ADDENDUM NO. 1
ENTIRE SHEET

DOWNTOWN CORRIDOR IMPROVEMENTS
CITY OF LAS VEGAS DEPT. OF PUBLIC WORKS
LAS VEGAS, NEVADA

PLAN AND PROFILE
STA.94+00 TO STA.106+00

DWG NO
107 v-
FILE NO
SHEET
SD-1

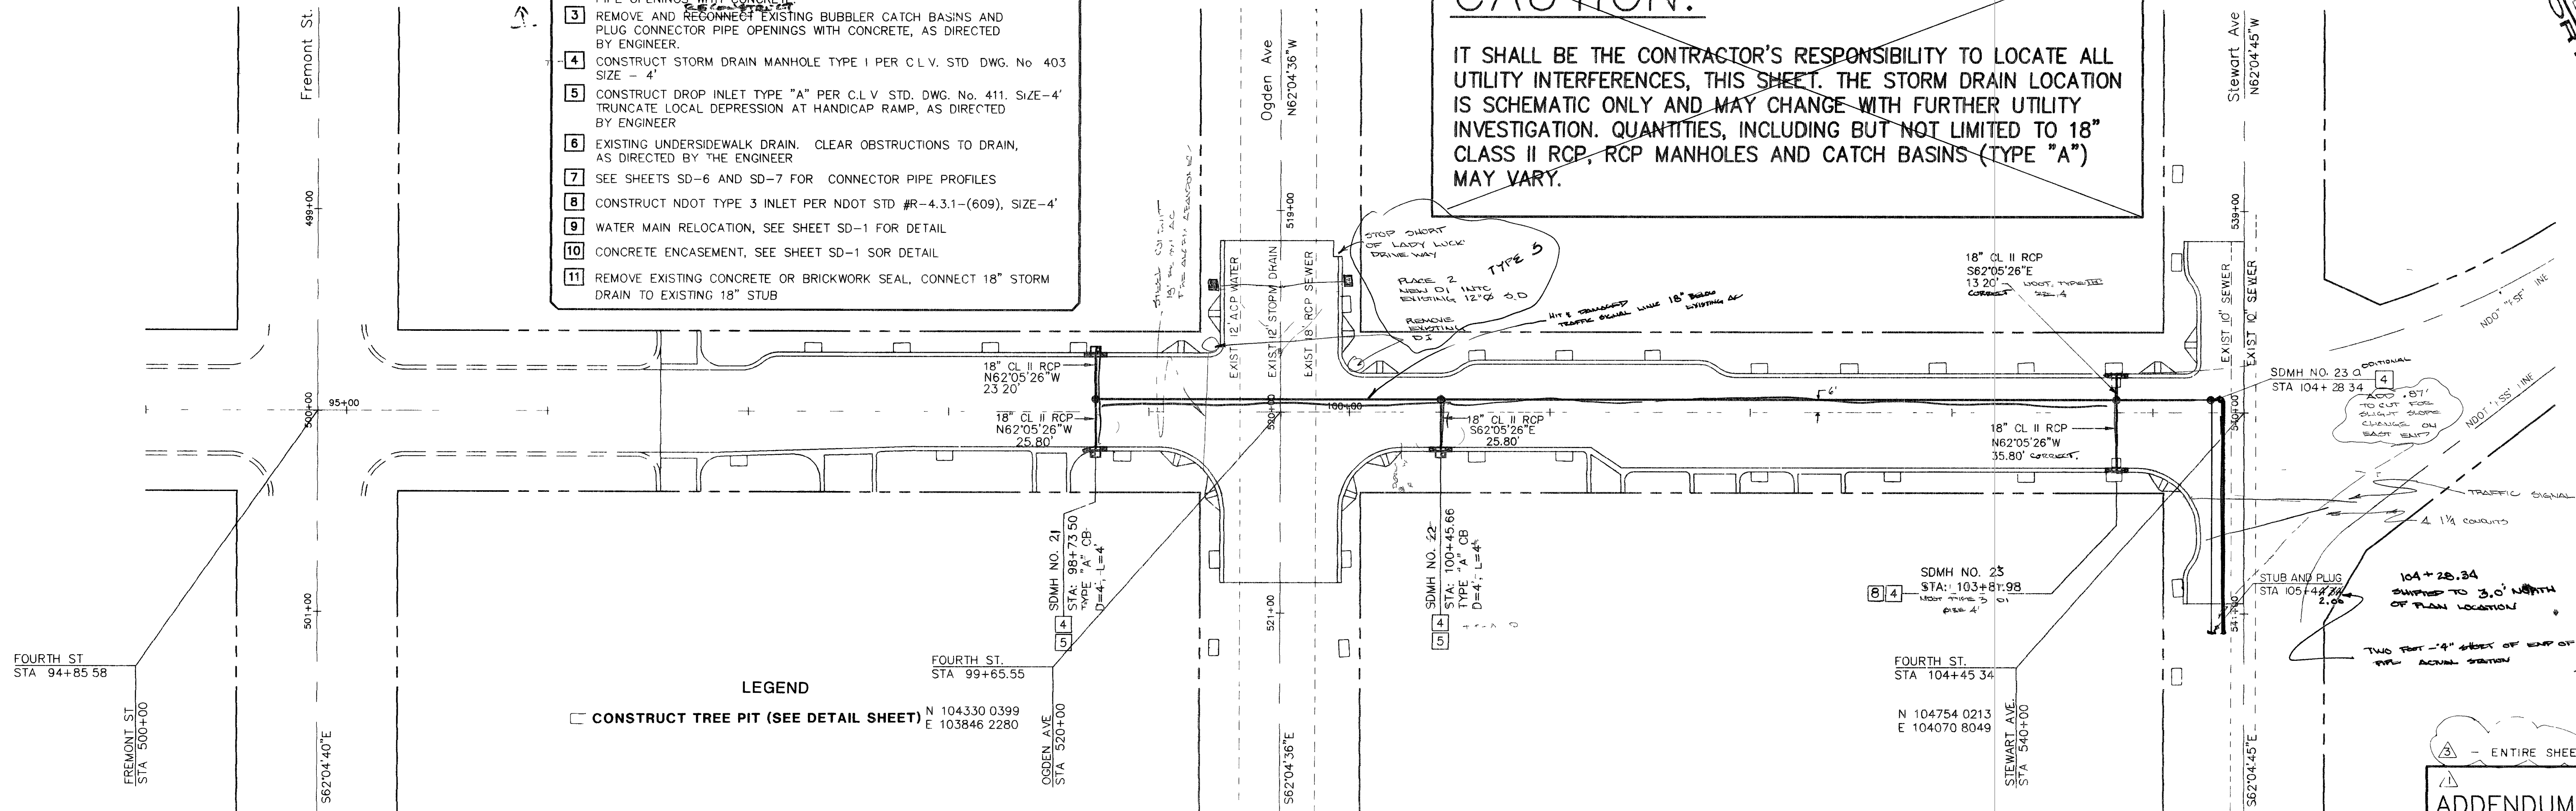
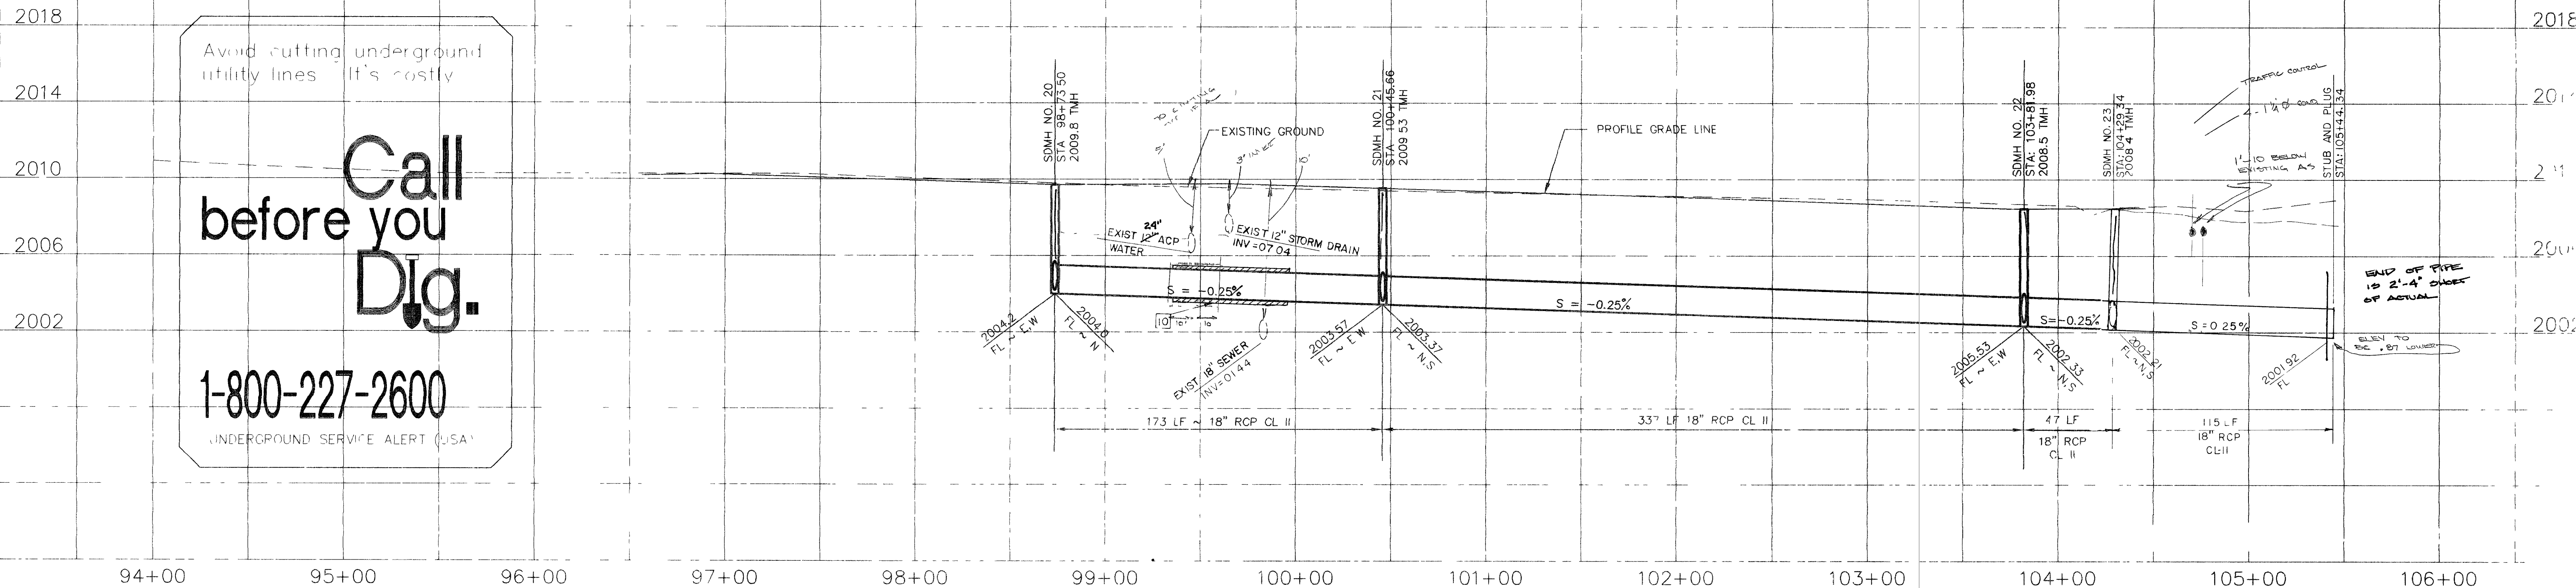
NO	REVISIONS	DATE	BY
1	REVISION 1, ISSUED AS ADDENDUM NO. 1, ENTIRE SHEET, ADD STORM DRAIN ON PLAN AND PROFILE	12/10/94	DBB
2	REVISION 3, ISSUED AS CCO ENTIRE SHEET, ADD UTILITIES IN PLAN AND PROFILE, CONC. ENCASUREMENT, MODIFY STUB OUT ON STEWART, MODIFY CB'S AT STA 103+81.98 TO NDOT TYPE 3	01/21/95	DBB
